Technical Bulletin

Bulletin No.: TCH-008-019 Effective Date: 7/15/94 Cancels: PRO-08-19 dated 5/1/92 Page: 1 of 6

Subject: The Holset Type E & QE Compressor Air Supply System with Bendix Air Dryer & Holset ECON Valve

Typical Holset Air Supply System With New AD-9 Installed

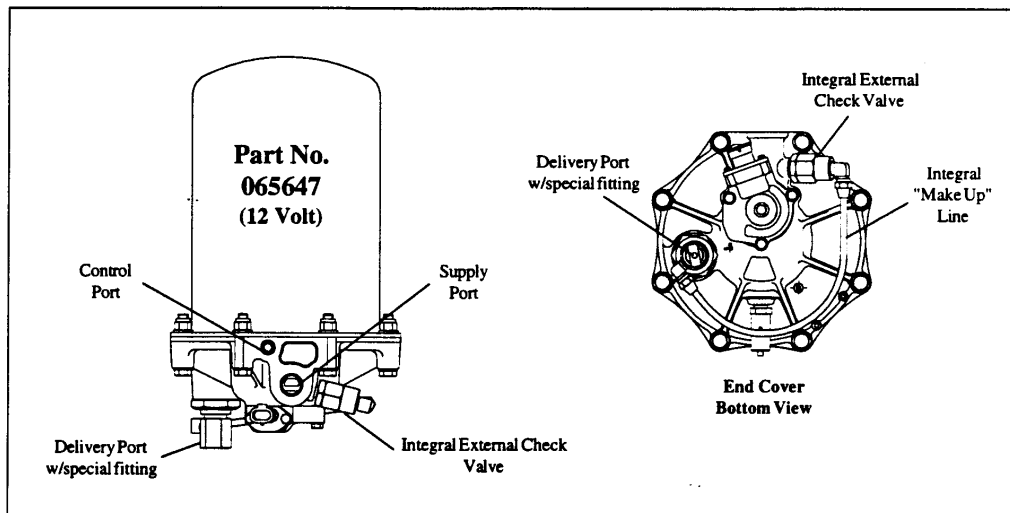
B. Simplifying The Air Supply System With A Bendix AD-9 "Drop In" Model Air Dryer

**NEW AD-9 "Drop In" Model Air Dryer w/integral "Make-up" Line & Check Valve
065647 - 12 Volt**

Typical Holset Air Supply System With Modification Kit 265088 Installed

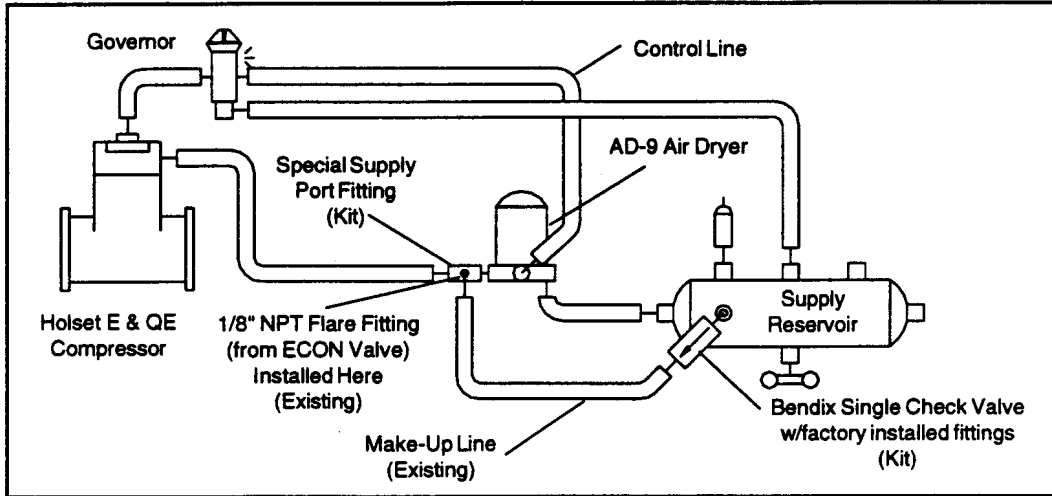
C. Modifying Existing AD-9 & Holset Compressor Installations With Kit 265088

Modification Kit 265088 can be installed in existing Holset and AD-9 installations to eliminate the ECON valve and special Holset check valve. The kit (265088) contains a new style, soft seat purge valve assembly along with a variety supply port fittings, parts, and instructions required to complete the installation and eliminate the Holset ECON valve and special single check valve.
